# Keystone RV Company

## SAFETY ADVISORY # 22-434

### Lippert Awnings

# AWNING INSPECTION AND WELD/SEAM REPAIR

**Fig. 1**

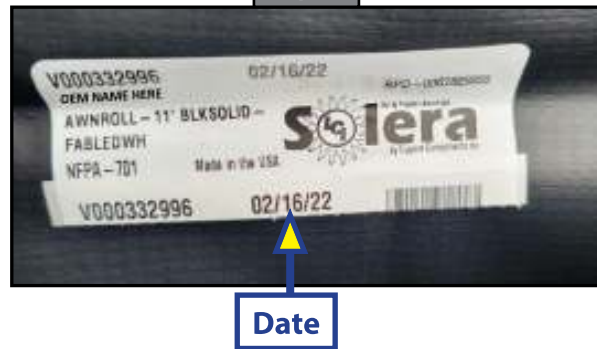
The purpose of this document is to provide guidance, as well as visual aides, to dealers performing inspection on units that may have insufficient awning weld(s). The inspection point is at the awning fabric seam at the awning rail at the wall of the unit (Fig. 1). This only affects awnings manufactured January 17, 2022 – June 14, 2022. The date of manufacture can be located on the variant code label (Fig. 2) located on the awning.

**Fig. 4**

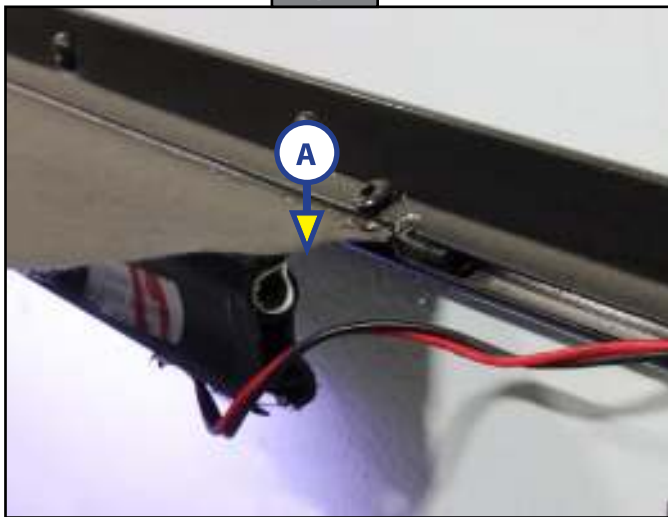
1. Position stepladder next to the unit to view the topside of the awning at the unit wall from either end (drive/idler side).
2. Inspect the weld near the awning rail (Fig. 4A).
  - A. Fig. 4 shows no separation at the seam. It does not require repair or replacement.
  - B. Fig. 5 shows separation at the seam (Fig. 5A).
    - I. If the separation is less than 6 inches, repair can be accomplished using the procedure described in [TI-434](#).
    - II. If the separation is over 6 inches it will require awning fabric replacement using the procedure described in [TI-166](#).
